Tesla, Inc. Service Bulletin		<i>Replace Suspension Components</i>
SB-25-31-005 June 9, 2026		R1		
Classification		Section/Group	Mobile Service	
Campaign Bulletin		31 - Suspension	Cannot Perform	All
Model	Model Year	Country/Region	Build Location	
Model Y	2025+	North America	Fremont, Giga Texas	
The model(s) and model year(s) listed are a general approximation of the affected VIN list. Refer to the VIN/Bulletin Tracker or Customer/Vehicle profile to determine applicability of this bulletin for a particular vehicle.

This Service Document supersedes SB-25-31-005 R0, dated May 8, 2026. This new revision, R1, removes Model Y Performance vehicles from steps instructing to replace the dampers, adds fasteners to the parts list, and updates the FRTs. Each content change is marked by a vertical line in the left margin. Discard the previous version and replace it with this one.

Figure 1

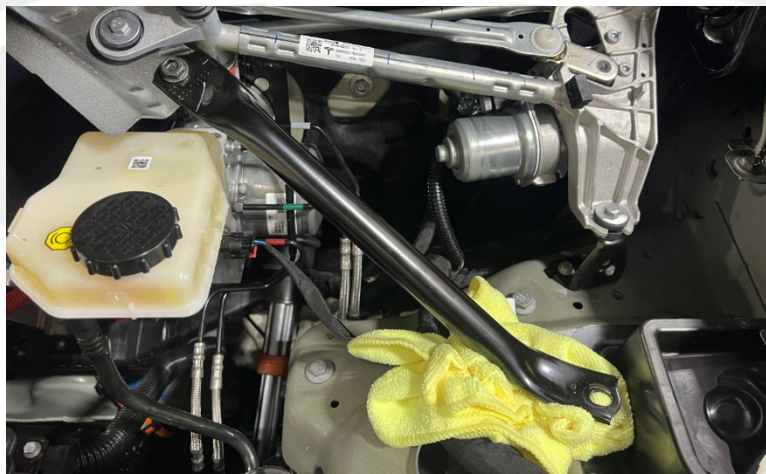
- If the rattling or knocking noise is present, continue to the next step.
 - If the rattling or knocking noise is not present or a different noise is heard, discontinue this procedure and use correction code S022531005.
2. Remove the bolts (x2, 13 mm) from the LH and RH wiper bracket pencil brace lower attachment points and swing the arms away from the bolted flanges, then wedge a shop towel between each of the braces and mounts to isolate the lower attachment points (Figure 1).
